**ANGEL PLACE
LEVEL 8, 123 PITT STREET
SYDNEY NSW 2000**

19 August 2021

1 CRESCENT STREET, HOLROYD PLANNING PROPOSAL (PP_2019_CUMB_002_0)

Images of Woodville Road (eastern side)

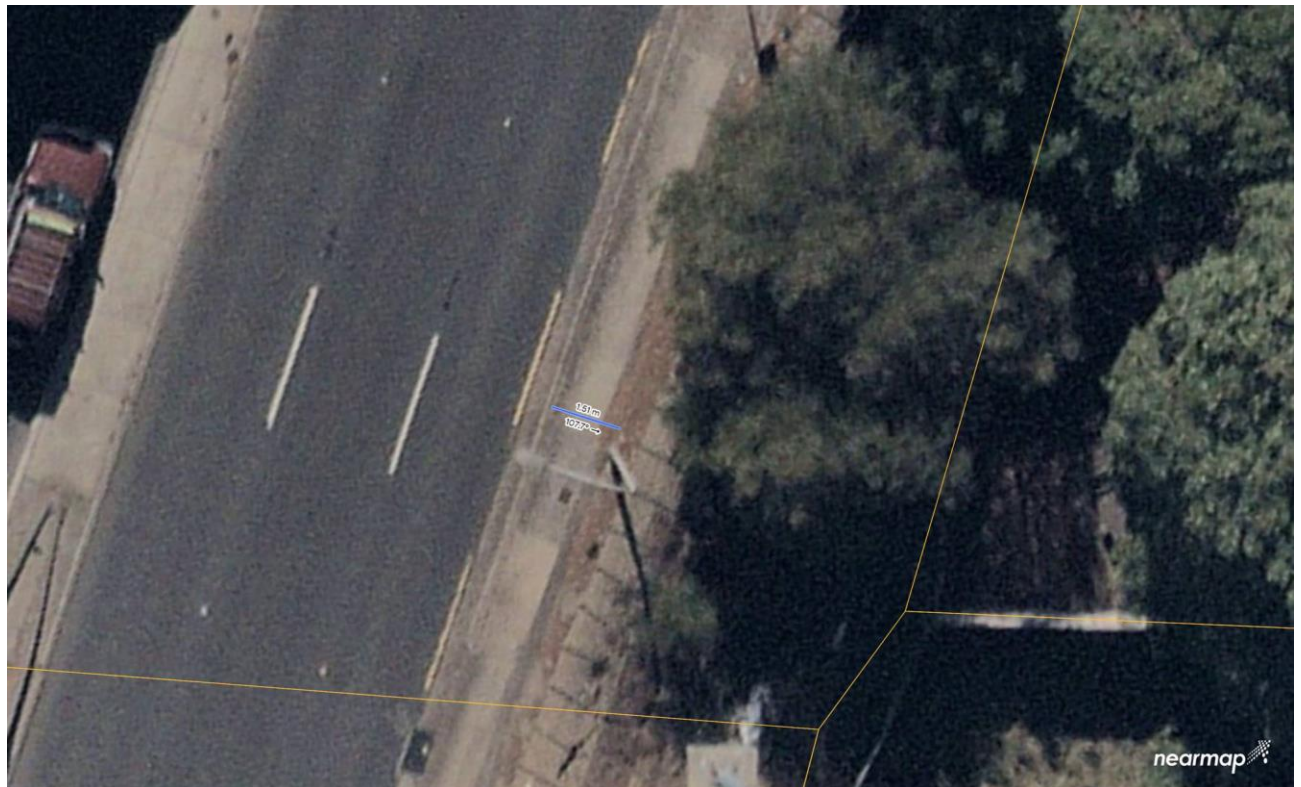
Images of the Woodville Road environment, in **Appendix B**, show the constrained and narrow road carriageway, including kerb that exist, resulting in a substandard and inappropriate positioning and lack of separation between pedestrians and traffic and the steep retaining wall to the east. This retaining wall forms part of the rail infrastructure and it is unlikely that it can be modified.

1. Looking south (narrow footpath, high embankment, damaged sign)

2. Looking north (no pedestrian protection, narrow footpath, unlikely to be DDA compliant)

3. Footpath measurement (kerb to embankment = 1.51m)

4. Railway Memorial (local heritage item on western side of Woodville Rd)

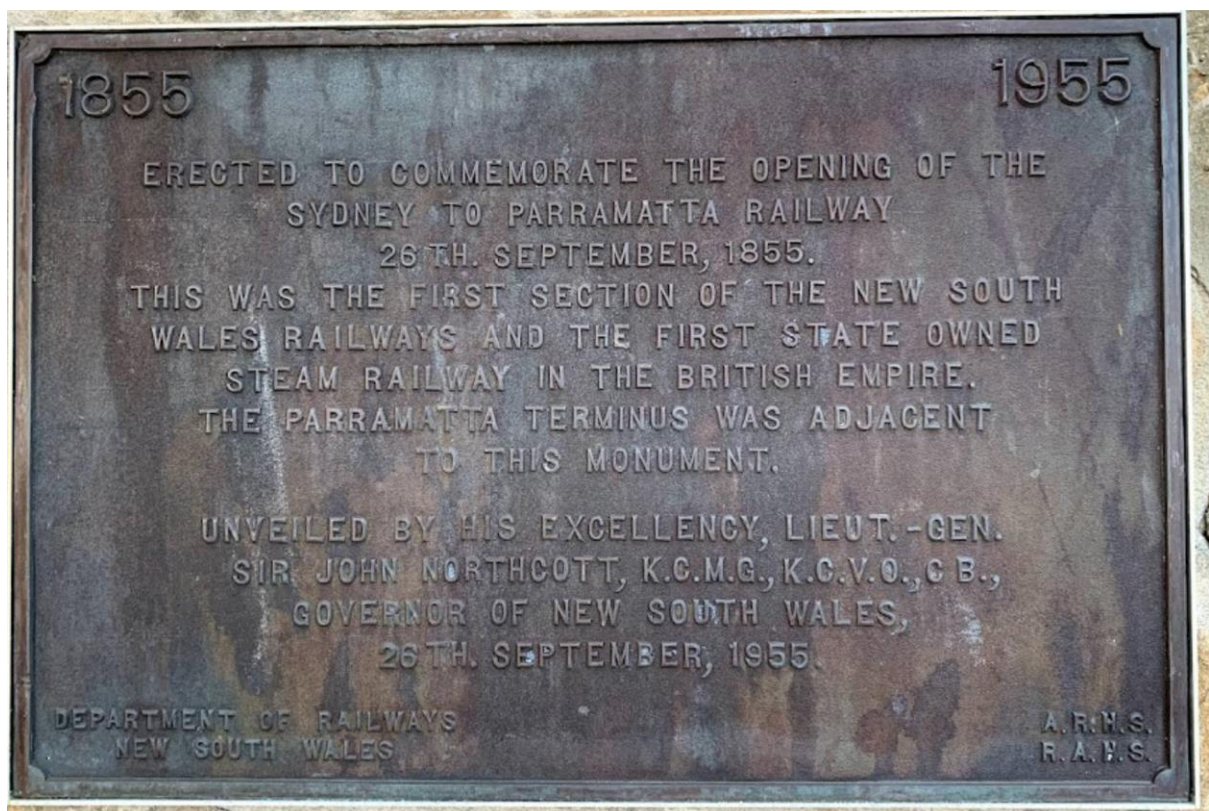
- The western side has a locally listed heritage item (I23 under Schedule 5 of HLEP) which is a railway memorial from 1855. The proposed siting has had no regard to the setting of this item.

westward, it would be hard up against the heritage memorial. This shows the lack of merit for the proposed location.
